10/539,665

Office Action Summary	Application No.	Applicant(s)	
	10/539,665	PAN, SHENG-GEN	
	Examiner	Art Unit	
	Dieu Hien T. Duong	2821

DETAILED ACTION

Fig. 1

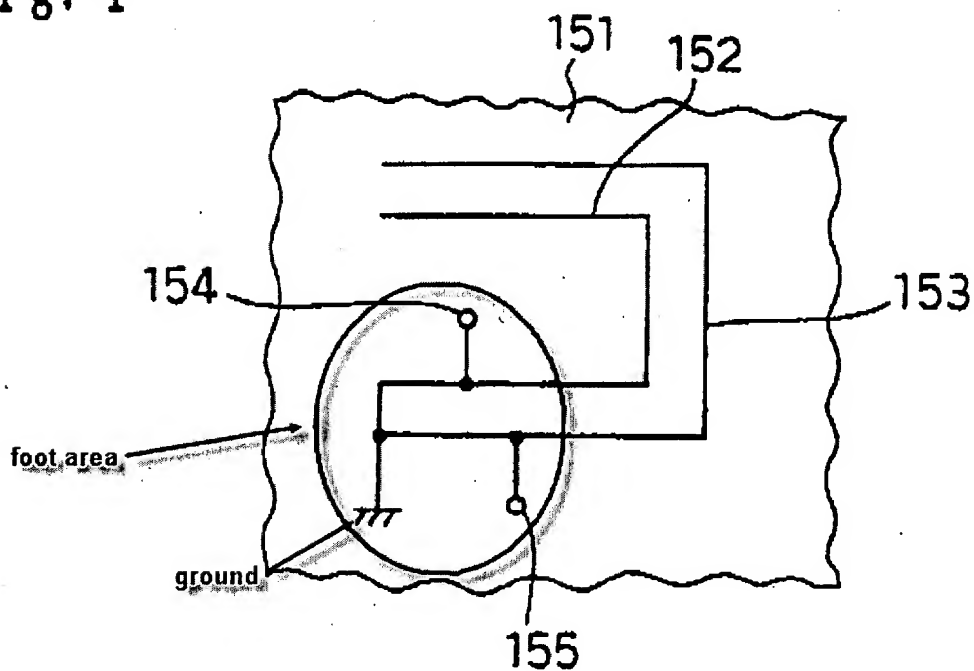
Regarding claim 6, Kane discloses, in Figures 1 and 16, an antenna structure having a substantially flat form with a ground connection, which is designed for use for at least two frequency bands, comprising two antenna branches (152, 153), which are electrically conductively connected to a foot area, wherein the foot area surrounds the

ground connection; two RF supply connections (154, 155) that are arranged at a distance from one another, provided in the foot area, between which the ground connection is provided, wherein the two antenna branches (152, 153) of the antenna structure are designed such that their associated frequency bands overlap; and an excitation circuit with an RF supply line, which branches to the two RF supply connections.
